Reference: Supporting Information to the Contingency Contaminants Management Decision Matrix

Reference: 2 AM-LUP Technical Meeting Commitment Number 13 Response – Lupin Mine Tailings Containment Area Dams Thermal Modelling Results

Reference: 2 AM-LUP Technical Meeting Commitment Number 6 Response – Geotechnical Review on the Long-Term Stability of TCA Dams

Reference: 2AM-LUP1520 Technical Meeting Commitment Number 10 Response – Cover Data from Lupin Mine Tailings Containment Area

TAILINGS CONTAINMENT AREA
CELL 3 COVER AND SURFACE
WATER MANAGEMENT

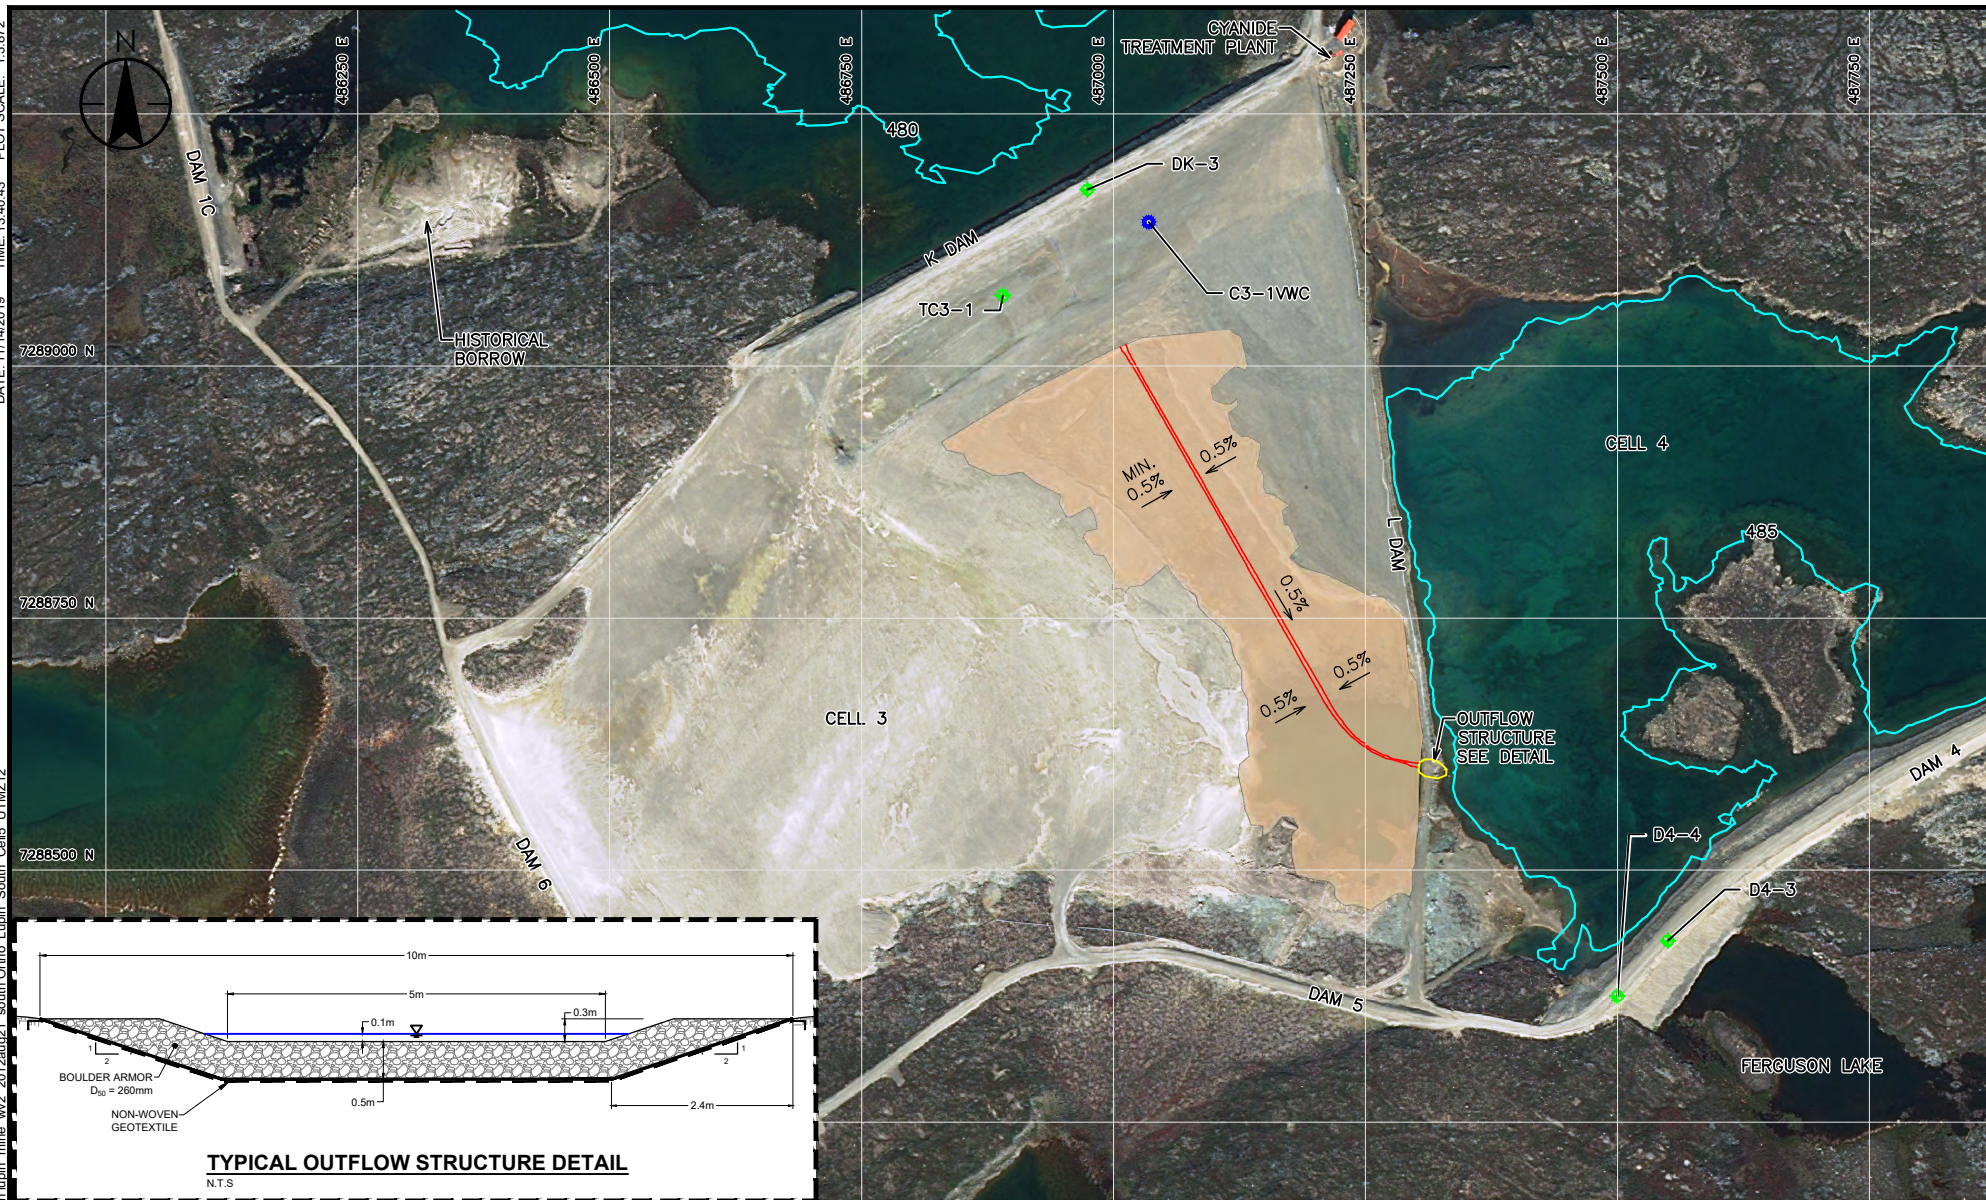
As part of the final closure and reclamation plan (FCRP), surface water management will be incorporated into the Cell 3 and 5 tailings cover to manage long term erosion potential. It is recognized that the existing topographies of the Cell 3 and 5 covers would have surface water flow over the dams that could cause erosion. The FCRP would incorporate surface water management into the to-be-constructed cover to minimize potential erosion of the dams. The to-be constructed tailings covers will be engineered and contoured to allow surface water to flow passively away from the face of the dam and into an engineered outflow structure. Both Cell 1 and 2 do not have significant gradient toward the dams and additional cover regrading is not required based on current information available. The design criteria for the surface water management on the covers are shown in Table 4.

The Cell 3 engineered cover design is shown on Figure 2 and Cell 5 engineered cover design is shown on Figure 3. These should mitigate long term erosion potential over the dam face.

Parameter	Value
Design Event	1 in 100-year
Design maximum flow	0.8 m ³ /s
Design maximum velocity	1.9 m/s
Cover maximum grade	0.5%
Outflow channel side slopes	Min. 3H:1V
Outflow channel bottom	5m
Outflow channel maximum grade	10%
Outflow channel armoring size	D ₅₀ = 0.26m

SLOPE STABILITY ANALYSIS
SECTION K – PERMAFROST CONDITIONS
STATIC CASE – LOCAL FAILURE

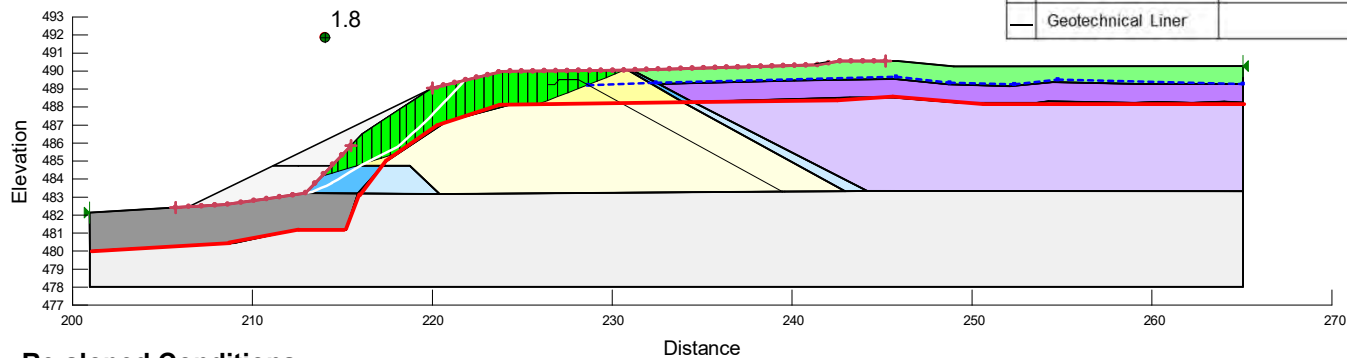
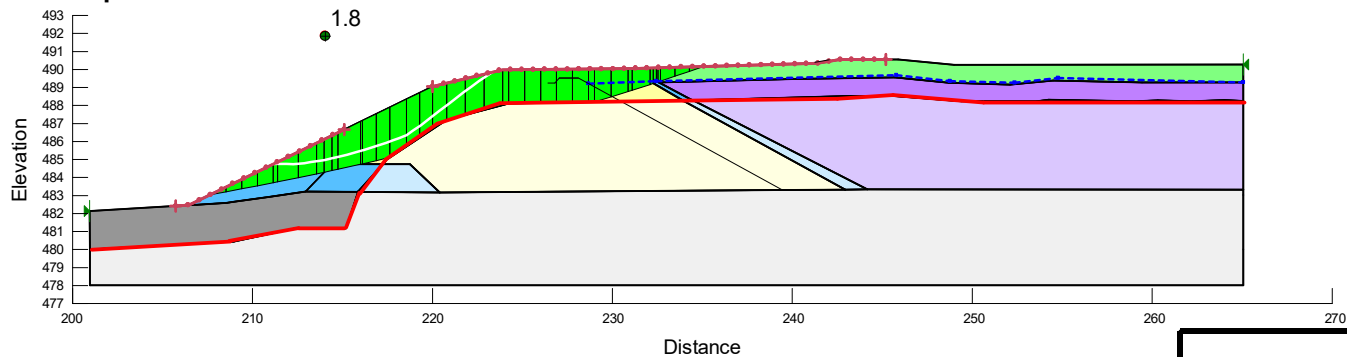
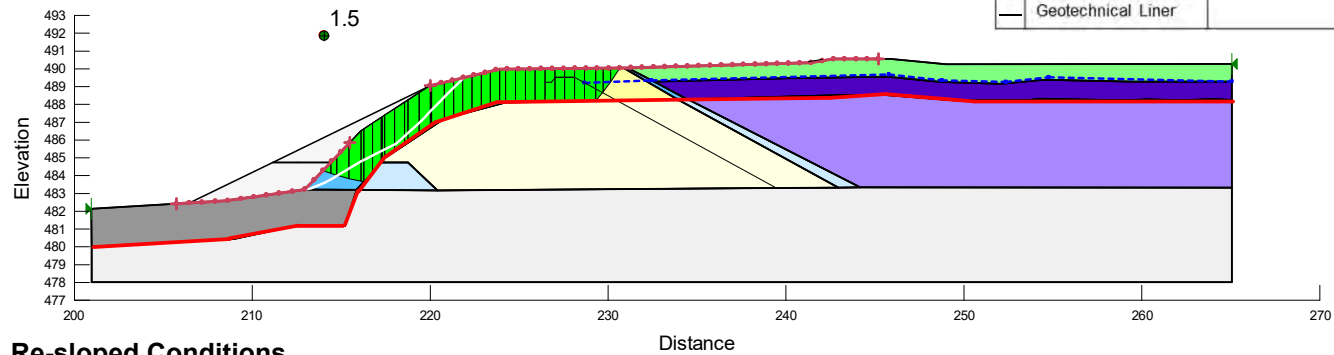
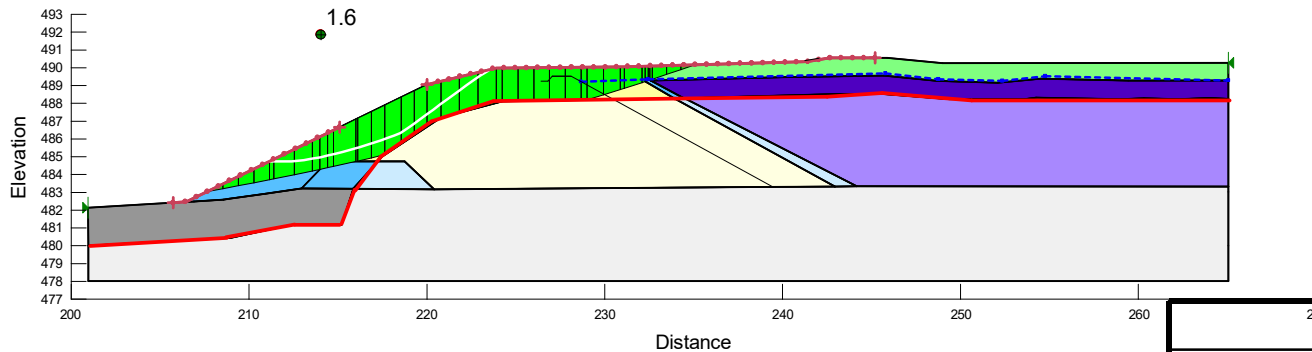
*FOS value does not meet design criteria for as-built configuration, repair and re-sloping is required for closure.

Most of the Lupin dams (2, 3, 3D, 4, 6, 1A, L and N) meet target closure FOS criteria in their current as-built conditions. Dams M and K require re-sloping to satisfy acceptable FOS criteria, as follows:

- Dam M: re-slope to 2.1H:1V;
- Dam K: re-slope to 2.1H:1V

Figure 1: Decision Matrix for Contaminants Exposed above Lupin Mine Tailings Containment Area Closure Water Levels

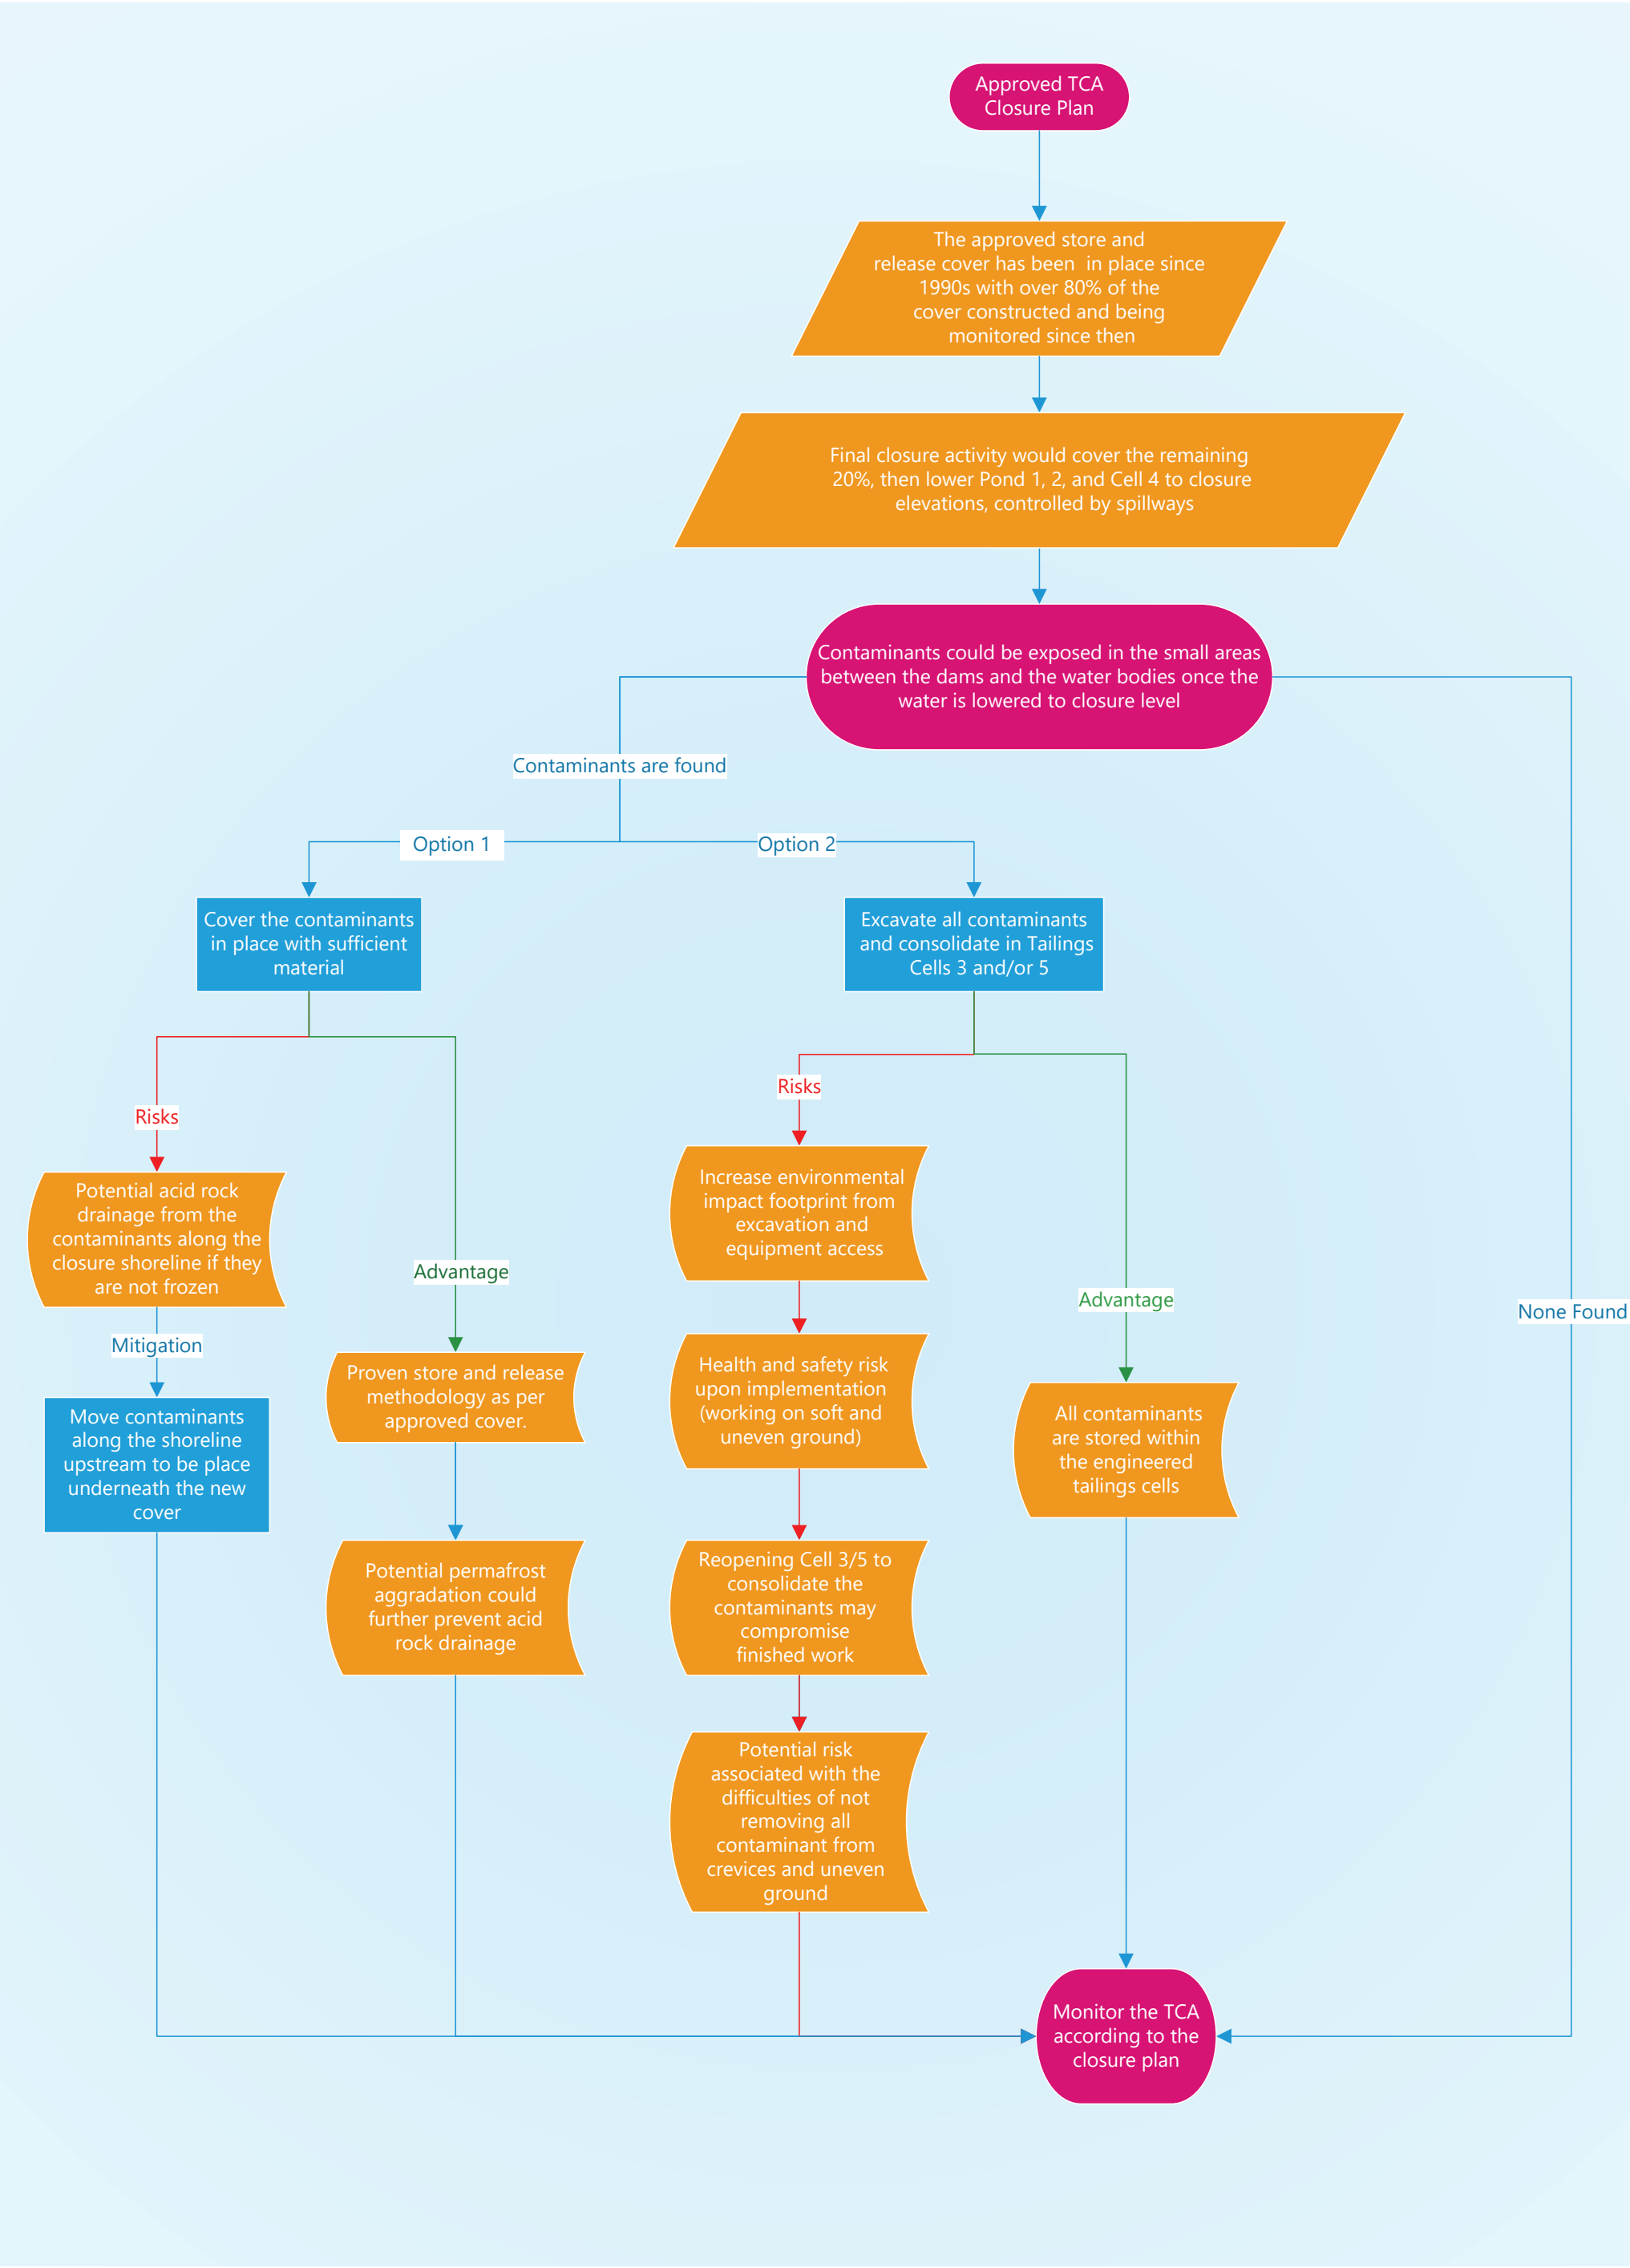
Commitment No. 8 was fulfilled by preparing the attached Figure 1 Decision Matrix for Contaminants Exposed above Lupin Mine Tailings Containment Area Closure Water Levels. The options, risks and advantages supporting each decision item in the matrix are detailed within.
